Municipal Planning Commission

AGENDA

Monday, April 3, 2023 — 7:00

SUBJECT: Master Plan Application Review

PHASE ONE - B
JOYCE'S GARDENS SUBDIVISION
DEVELOPER: LIBERTY PROPERTIES
ENGINEER: THE BRAY FIRM

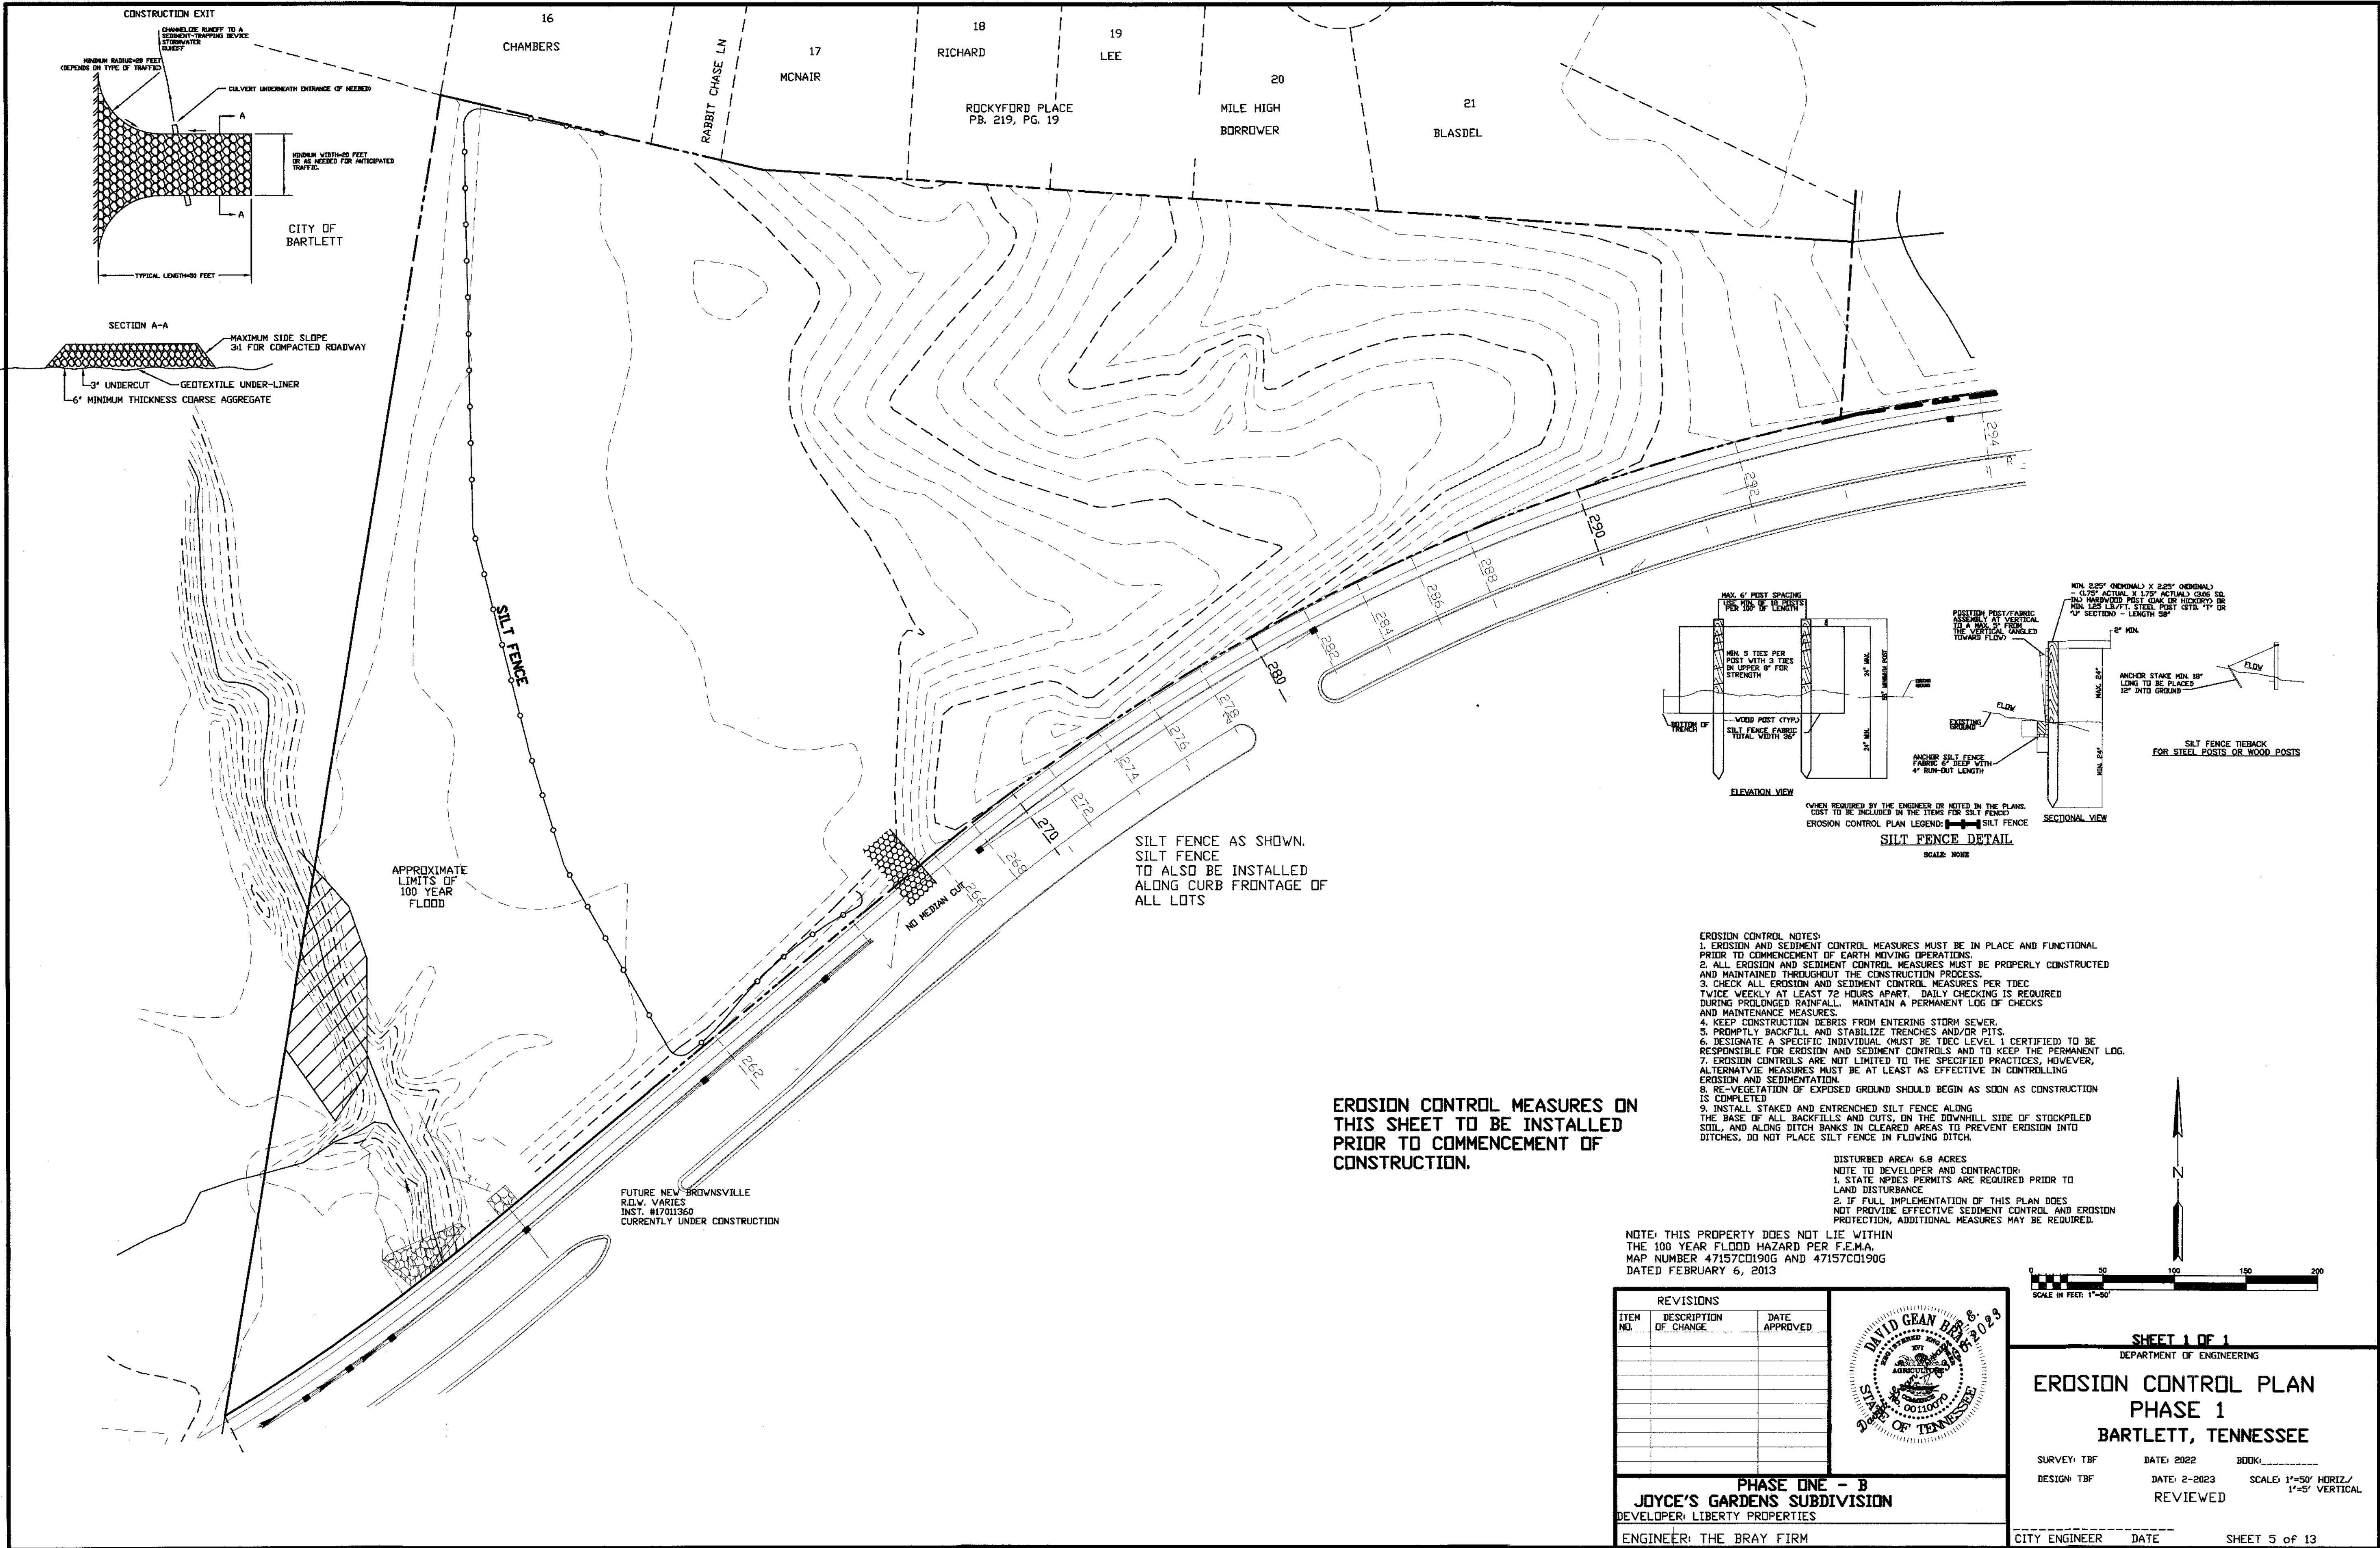
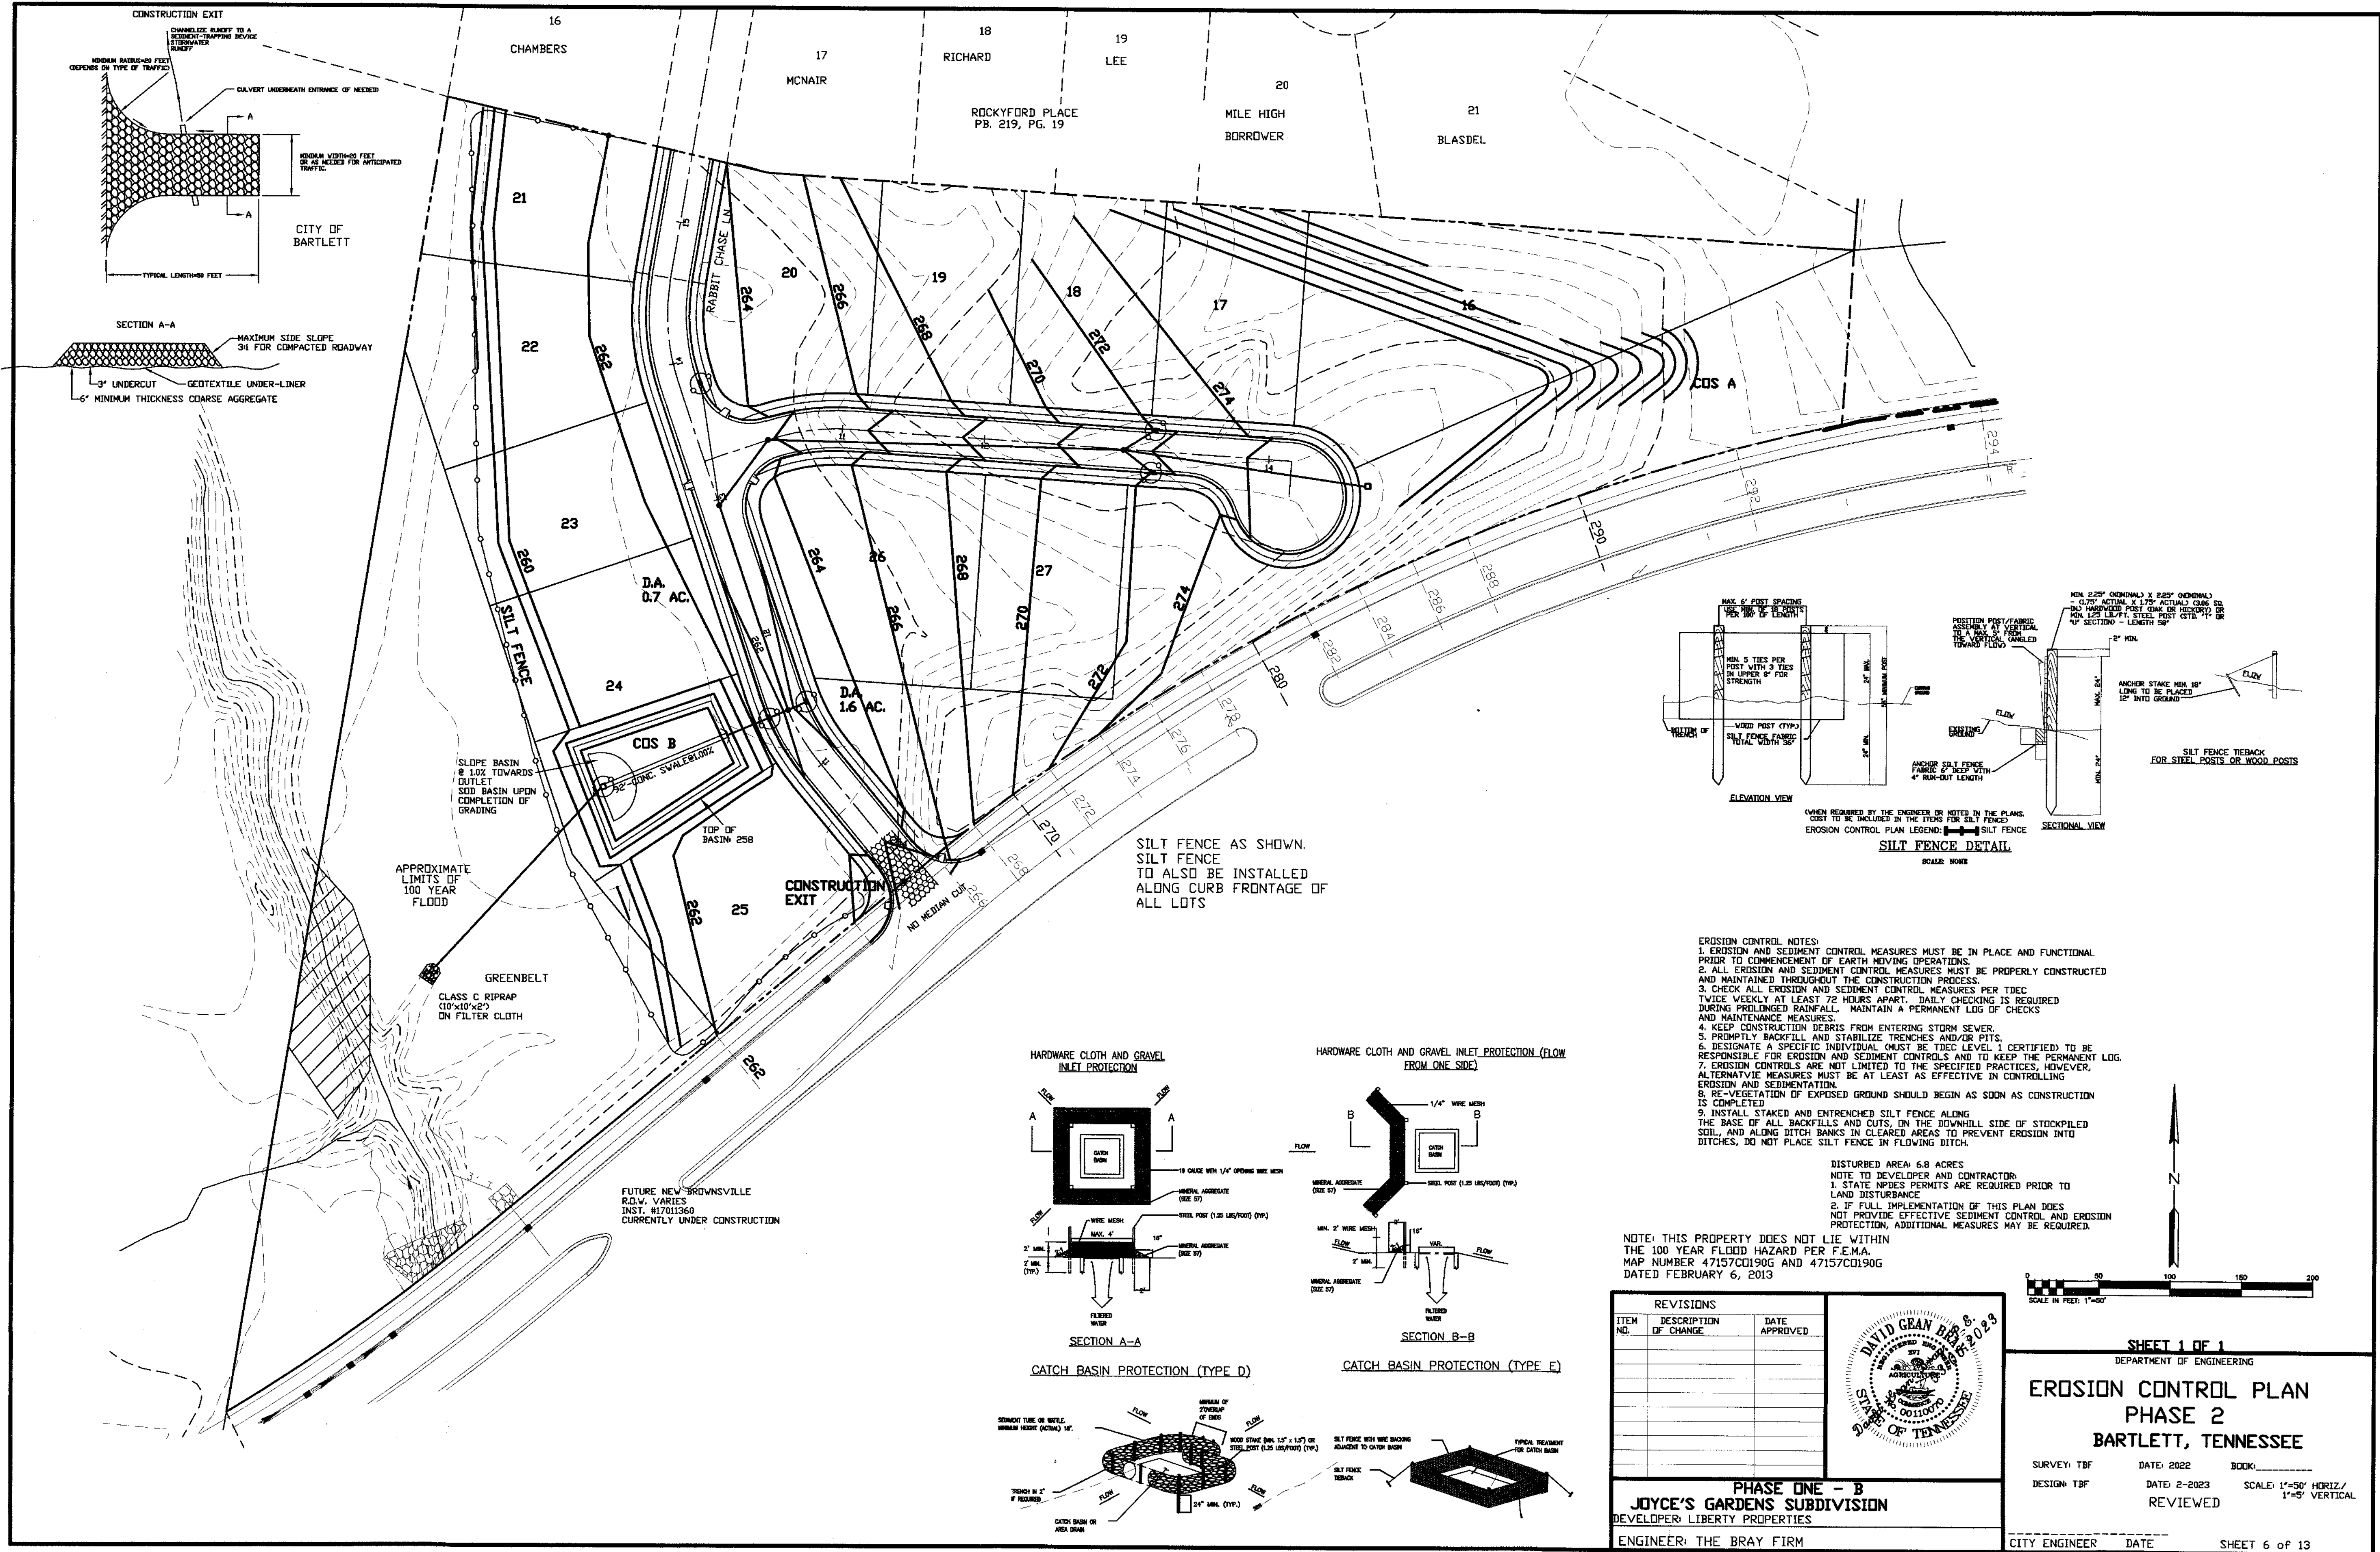
12. All COS shall be maintained by the Homeowners Association. This includes the detention basin and outlet structure.
13. Drainage easement shall be shown in COS B to include the pipe and structure 4 into the detention basin as well as structure 2 and the pipe out of the detention basin.
14. Sidewalk table shall be added. Sidewalk on New Brownsville Road are 8 feet wide.
15. Show location of subdivision concrete monuments to be installed as required by the subdivision ordinance.

16. The engineer shall provide a copy of the SWPPP (Storm Water Pollution Prevention Plan) that has been or will be submitted to TDEC (Tennessee Department of Conservation).
17. Prior to any work being started, an NOC (Notice of Coverage) from TDEC must be received and a copy submitted to the City of Bartlett.
18. Metal posts with wire-backed fence are required on the proposed silt fences.
19. Sediment basins may be required during construction.

20. The detention basins will be maintained by the HOA.
21. Emergency spillway will be required on the detention basins.
22. Applicant's engineer shall submit the stamped and signed detention calculations for the proposed detention basin and show the 'pre' and the 'post' runoff for the 2, 5, 10, 25, and 100 year storms. There should be one foot of freeboard above the top of the basin's wet storage elevation.
23. Pipe tables will be required and columns shall be provided for as-built data.
24. Drainage basins entering and exiting shall be shown on plan and any point drainage source entering or exiting the site should be connected via pipe.
25. Detail sheets shall be required.

26. Sewer service detail shall be updated to current.
27. Tracer wire detail shall be added.
28. Sewer services for lots 16 and 25 should be located by a property line to facilitate driveway installations.

29. Sewer service locations for lot 19 needs to be shown.
30. Area for as-built information shall be added.

1. The applicant shall rename the subdivision to Joyce's Gardens Planned Development since this development is being approved as a planned development in lieu of a standard subdivision.

2. The applicant shall rename COS C to COS A since COS C is included in Phase 2.
3. The applicant will need to add a note to the plat to deny driveway access to New Brownsville Road for Lots 25 and COS A.
